MIDWAY MFG. CO.

TABLE OF CONTENTS

S E R V I C E B U L L E T I N

ANTI-PENNY DEVICE INSTALLATION

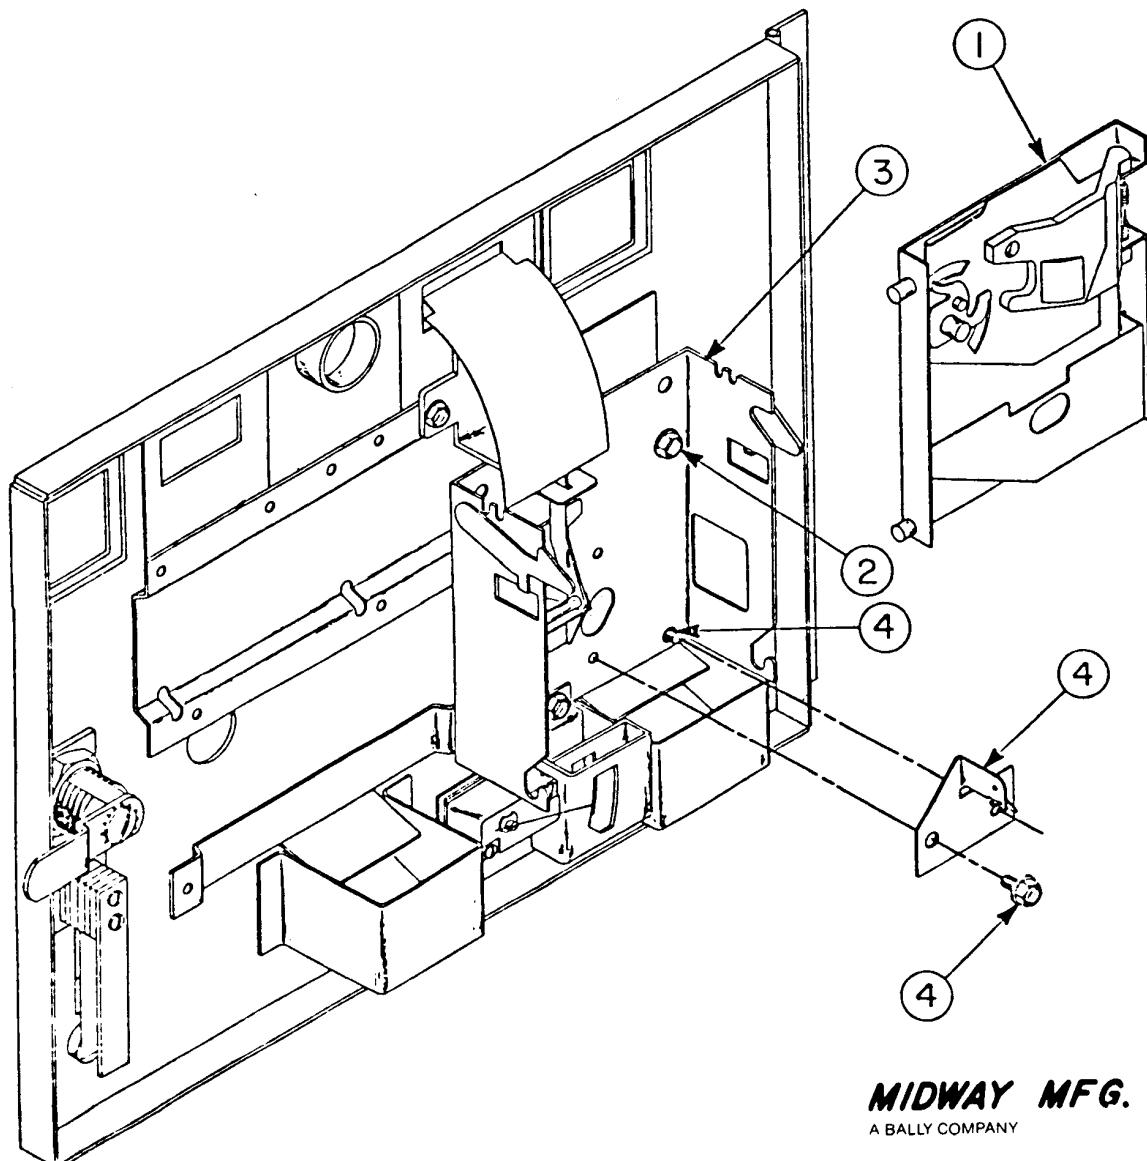
CONDITION: Flipping pennies into return cup for free games.

Order from the Midway Parts Department an Anti-Penny Device Field Kit.
Part number A090-00064-0000.

1. REMOVE COIN ACCEPTOR FROM BRACKET.
2. REMOVE (3) HEX HEAD SCREWS THAT HOLD BRACKET TO DOOR.
3. REMOVE BRACKET FROM DOOR.
4. INSTALL ANTI-PENNY DEVICE MIDWAY PART NO. A090-00064-0000 USING (2) 6-32 x 5/16 SLOT HEX HEAD SCREWS MIDWAY PART NO. 0017-00101-0555. MOUNT DEVICE WITH 1 SCREW FROM THE FRONT AND 1 SCREW FROM THE BACK OF BRACKET AS SHOWN.
5. SCREW BRACKET BACK TO DOOR AND SNAP COIN ACCEPTOR BACK IN PLACE.

FIGURE 1

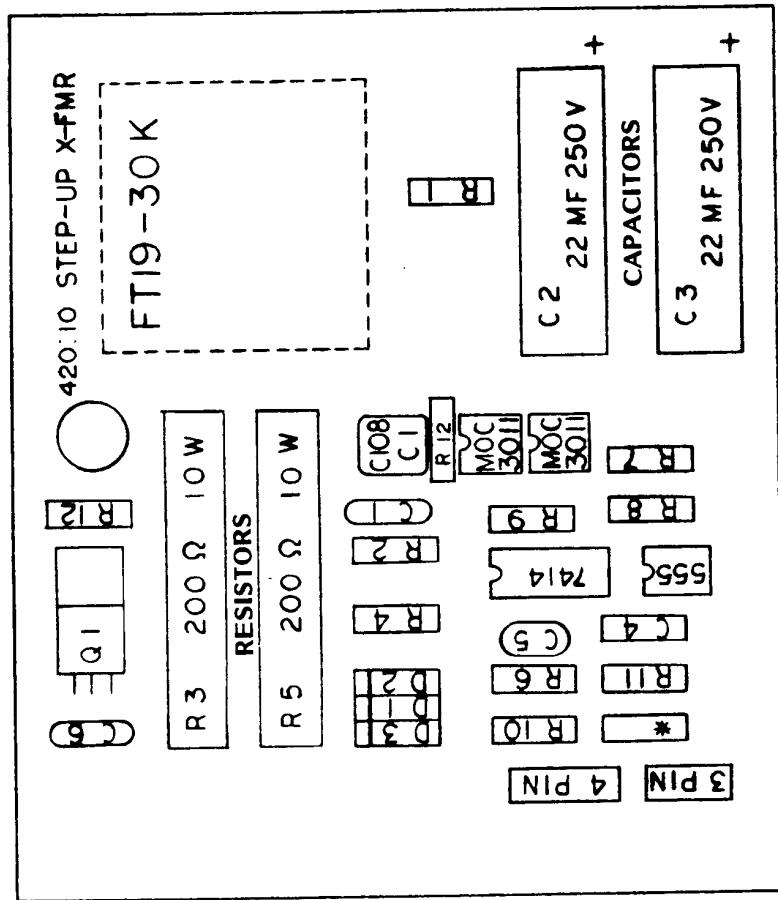
SUBJECT: Strobe unit PC A084-91359-B645
Serial No. 101 to 3700

MODIFICATION: (see figure #1)

1. Change resistor R3 and R5 to one of the following values.
 1. 300 ohms, 20 watts, 10%.
 2. 310 ohms, 20 watts, 10%.
2. Capacitor C-2 and C-3 should be 22MF., 250 V.
3. Check electrically.

**NO. 645-SPACE ENCOUNTERS-UPRIGHT
SWITCH AND HAND GRIP ASSEMBLY INSTRUCTIONS**
(KIT ASSY. NO. A645-00042-0000)

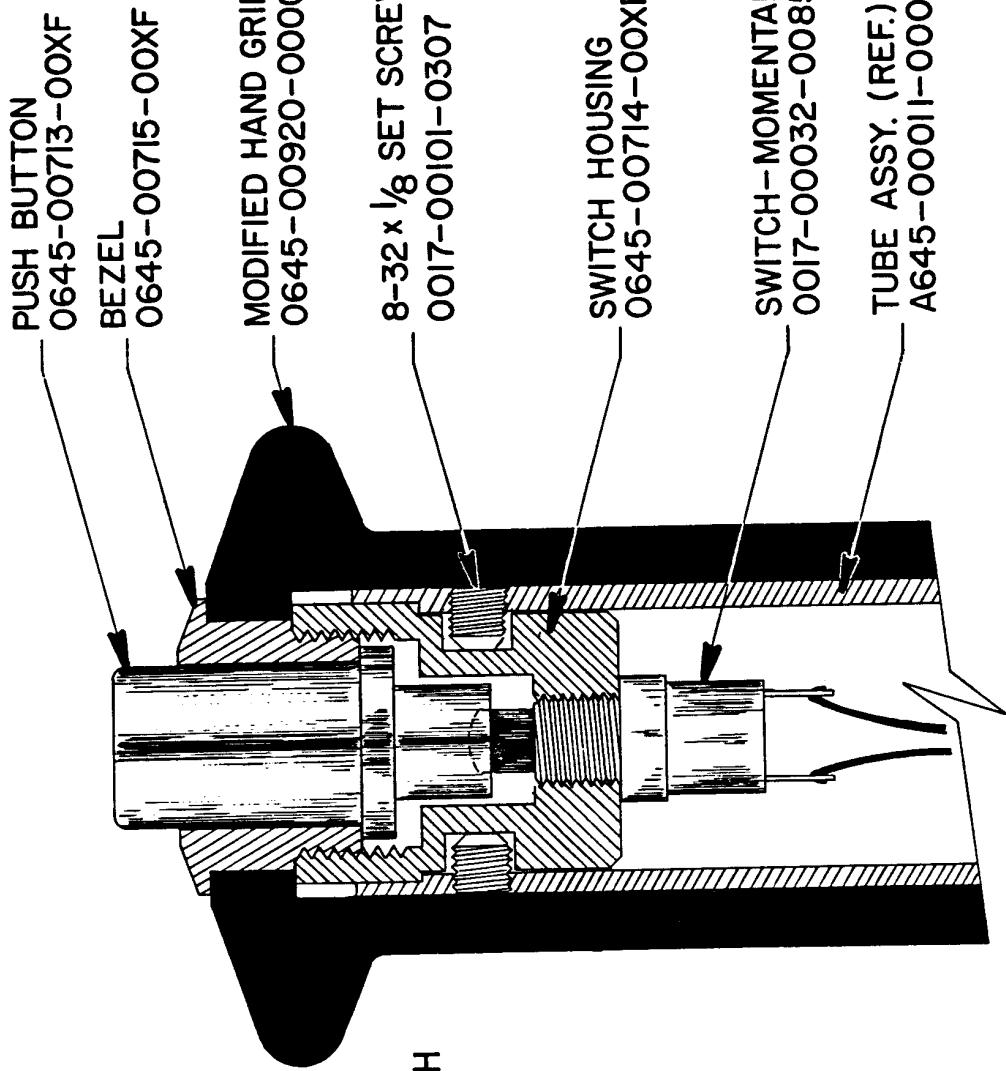
1. Due to field failures a new trigger switch is now available.
2. The switch and hand grip assembly kit may be ordered from the parts department. (A645-00042-0000).

- APPLY LOCTITE NO. 242 (P/N 0017-00009-0238) TO ALL THREADS BEFORE ASSY.
- SWITCH TO BE WIRED PRIOR TO ASSEMBLY.
- SCREW SWITCH INTO BOTTOM OF SWITCH HOUSING UNTIL SHOULDER BOTTOMS ON SWITCH HOUSING AS SHOWN.
- SLIDE SWITCH AND HOUSING ASSY. INTO TUBE. TIGHTEN SET SCREWS(2) TO RETAIN.
- SLIDE PUSH BUTTON INTO SWITCH HOUSING.
- PUSH RUBBER GRIP ONTO TUBE UNTIL FULLY SEATED.
- PUSH BEZEL ON PAST LIP OF RUBBER GRIP AND ENGAGE THREADS. TIGHTEN UNTIL FULLY SEATED.

Figure #1

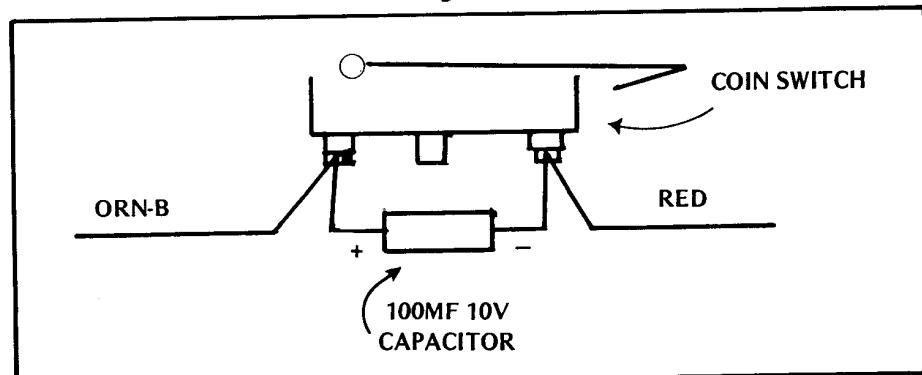
SUBJECT: Loss of Credit

MODIFICATION:

1. Install 100MF 10V capacitor to coin switch terminals as shown in Figure #1.
2. Capacitor is only needed at one coin switch.
3. Check game electrically.

FIGURE 1

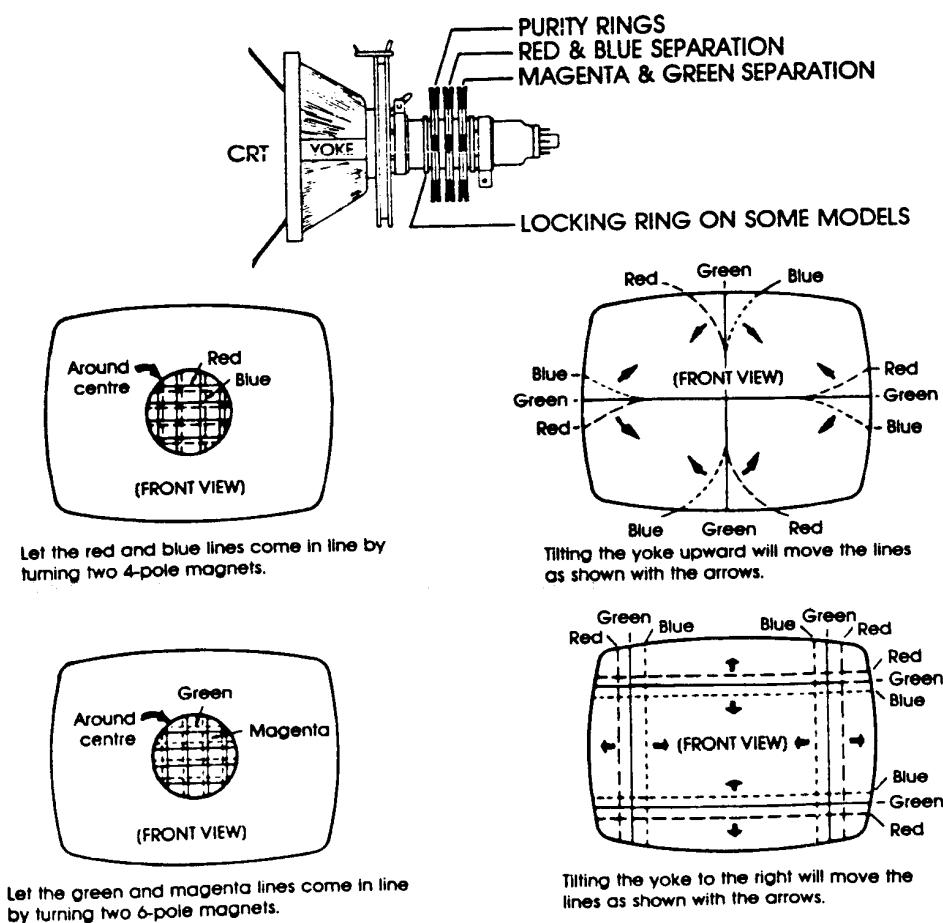
SUBJECT: Electrohome 19" Color Monitor

- A. Tilt the yoke up, down, left and right to achieve convergence around the edges. Secure with one temporary wedge.
- B. Rotate the center rings to adjust the red and blue separation.
- C. Rotate the rear rings to adjust the magenta (red-blue) and green separation; when best results are obtained, seal the rings with nail polish.
- D. Remove the temporary wedge from the yoke. Tilt the yoke again to adjust the edges of the screen for minimum separation and insert three new wedges. These should have adhesive added to hold them permanently.

See figure #1.

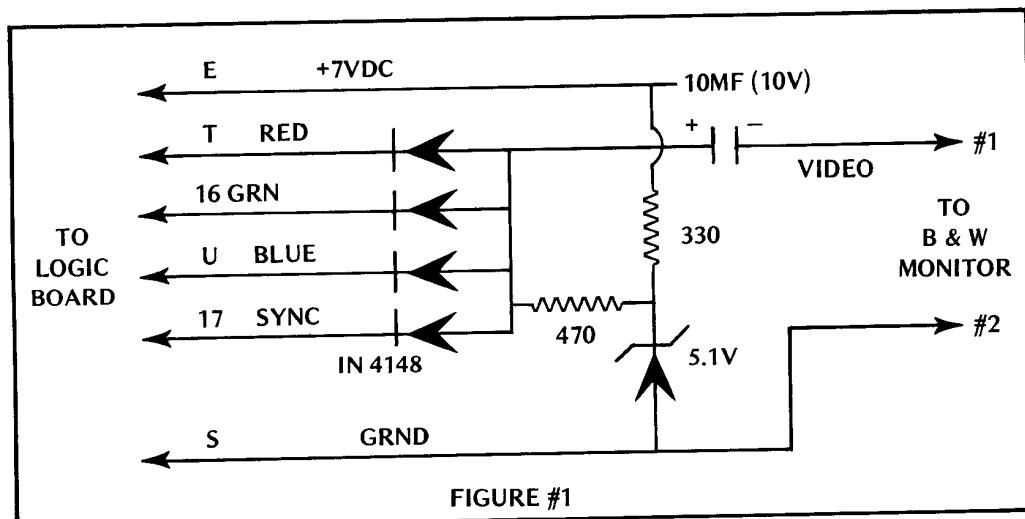
MODIFICATION:

To bench test a Galaxian logic board with a black and white monitor, the following change must be made (see Figure #1):

FIG. #1

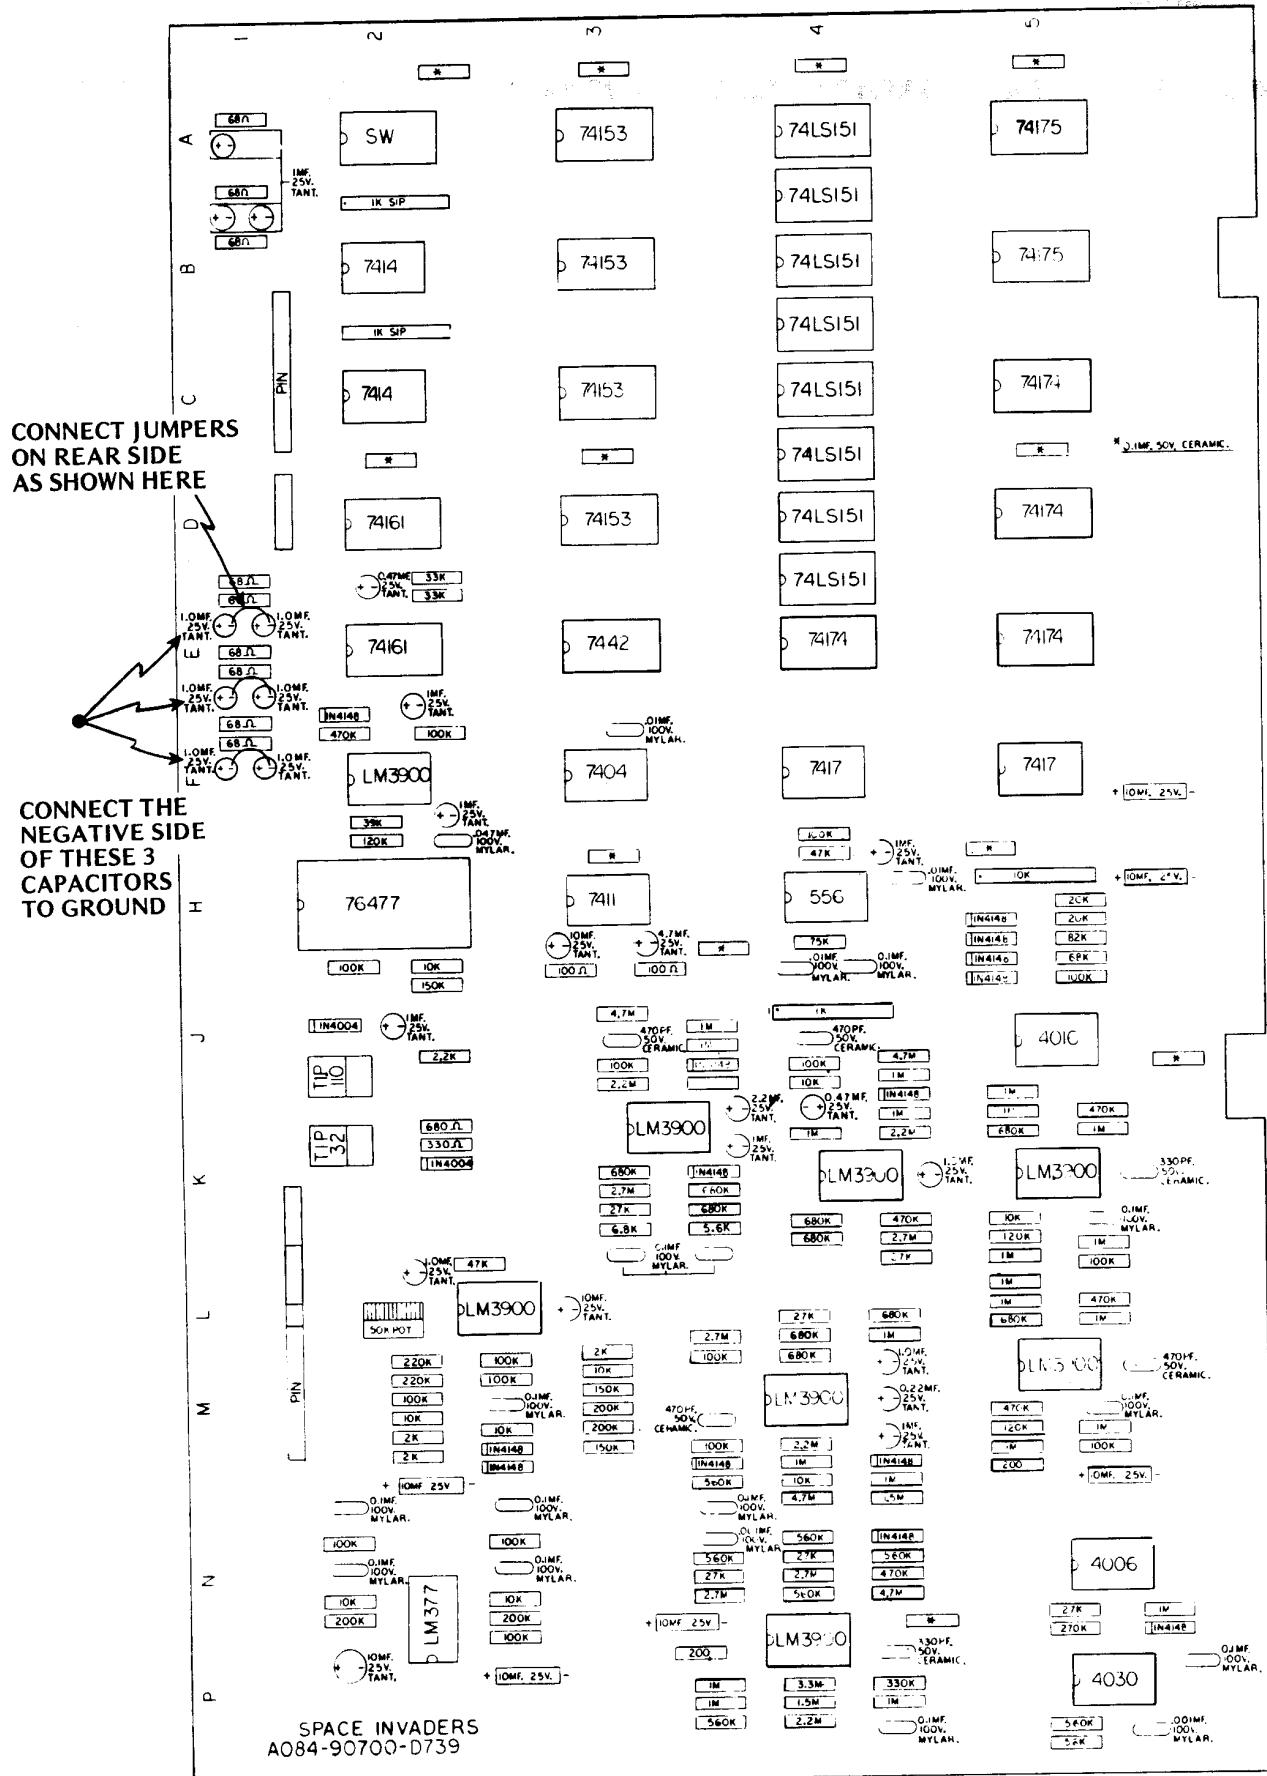
MODIFICATION:

1. All A084-90700-739-D game boards have three capacitors which are not grounded (RRC Network).
2. Refer to Figure #1 for the location of 1.0MF-25V capacitors.
3. On rear side of game logic board, solder jumper wires from negative side of capacitor to ground (See Figure #1).
4. Check coin and control circuits electrically.

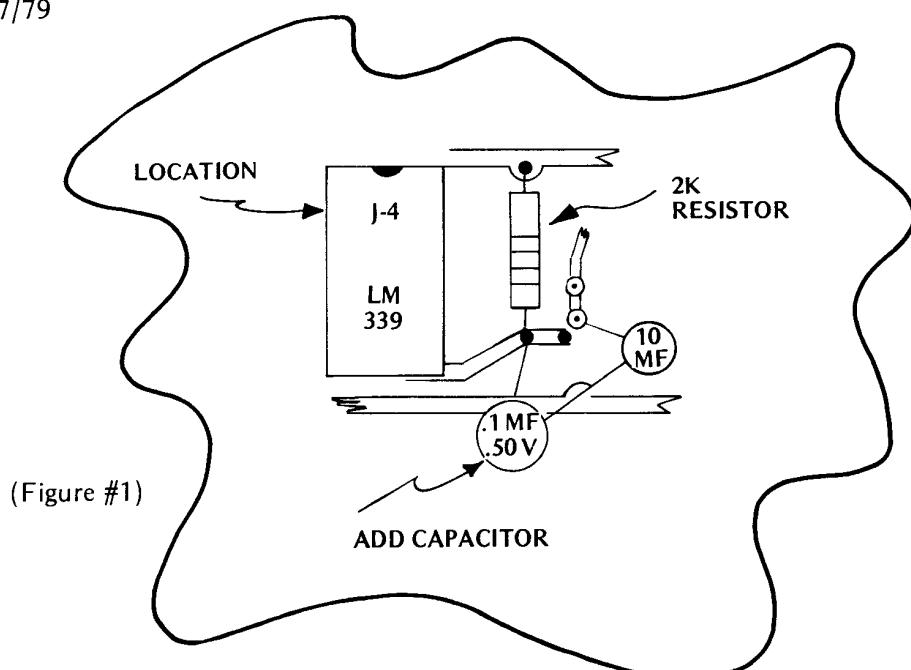
CONDITION: Premature Game Over (games serial #101 to 300)

1. Solder 0.1 MFD disc capacitor to the mother board PC A082-90400-B000, location J-4. (See Figure #1)
2. Check out game electrically.

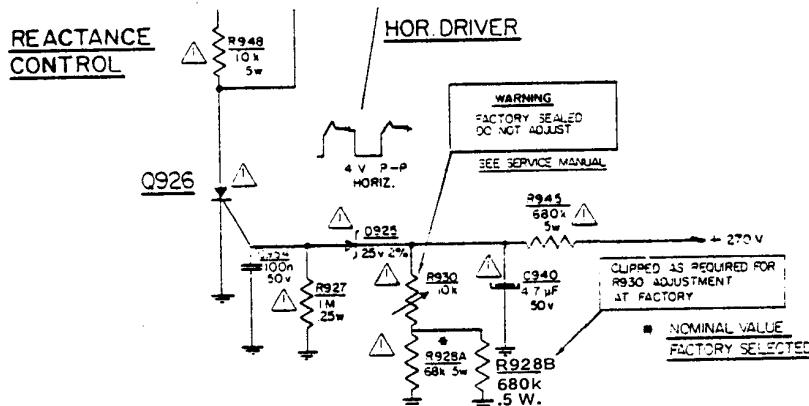
SYMPTOM: TV loses anode voltage, 30,000 VDC approximately, after 5 or 6 seconds.

CAUSE: On the Electrohome color monitor, the high voltage is protected by an overvoltage protection circuit. This circuit is probably too sensitive, or the 125 volt DC power supply is faulty.

SOLUTION: First determine if 125 volts DC is available on the power supply PCB. C940 could make it more sensitive if it has excessive leakage. Check R928B 680k .5 watt. If it's missing or clipped out, replace it. If R928B 680k is being used, change this resistor to one with a value of 510k .5 watt. If it is still too sensitive, change resistor to 470k .5 watt.

FIG. #1

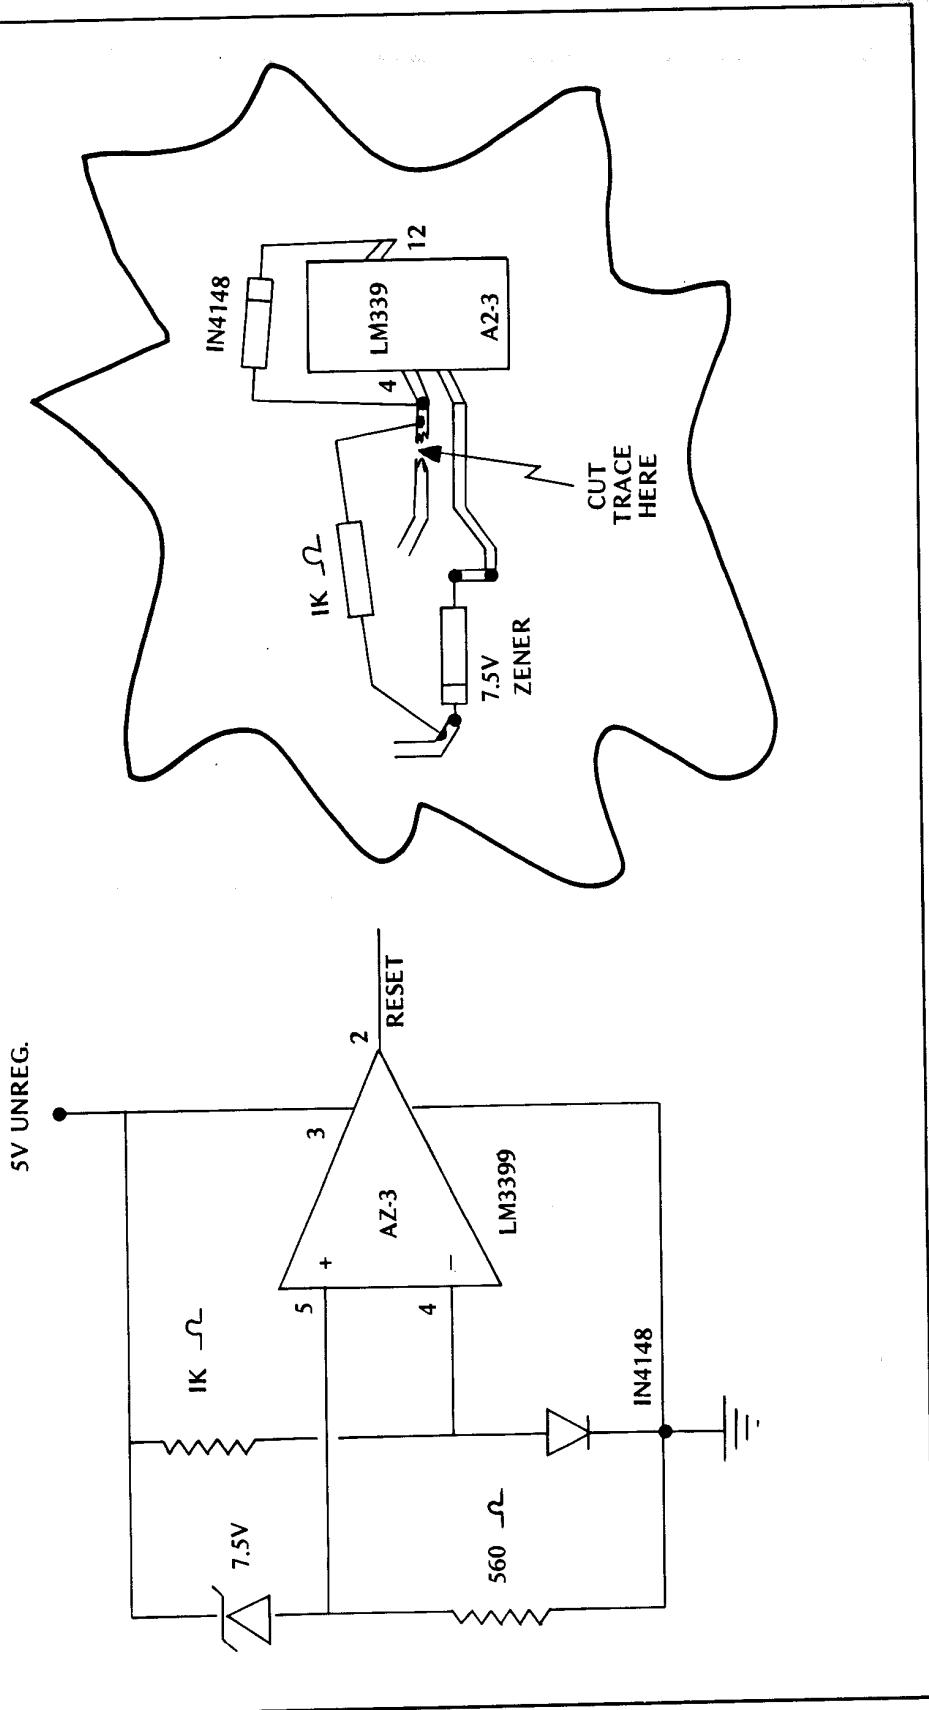
POWER RESET MODIFICATION
ROTATION VIII

1. Replace the 2.7 volt zener in power reset circuit with a 7.5 volt zener.
2. Cut trace at pin 4 LM339 location A2-3. (See Fig. 1)
3. Solder a 1K resistor from pin 4 LM339 to the cathode of the 7.5 volt zener. (See Fig. 1)
4. Solder a IN4148 diode from pin 4 LM339 to ground (pin 12 LM339).
5. Check game out electrically.

FIGURE #2

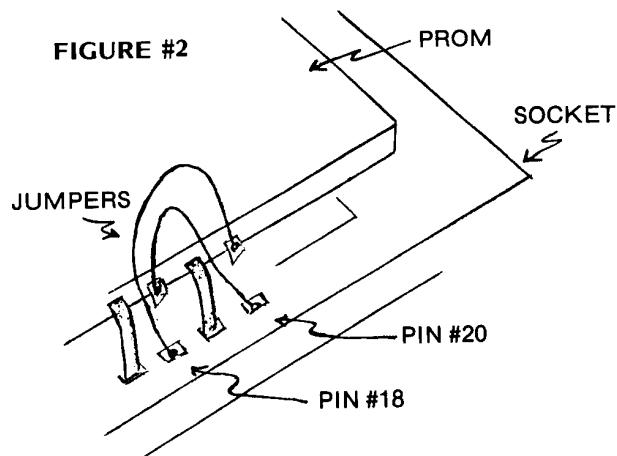
SUBJECT: 8516 & 2716 Prom Strapping Information (16K)

1. Refer to figure #1 for proper strapping of jumpers and capacitor removing or relocating.
2. Cut pins #18 and #20 of each prom and jumper as shown in figure #2.
3. Check electrically.
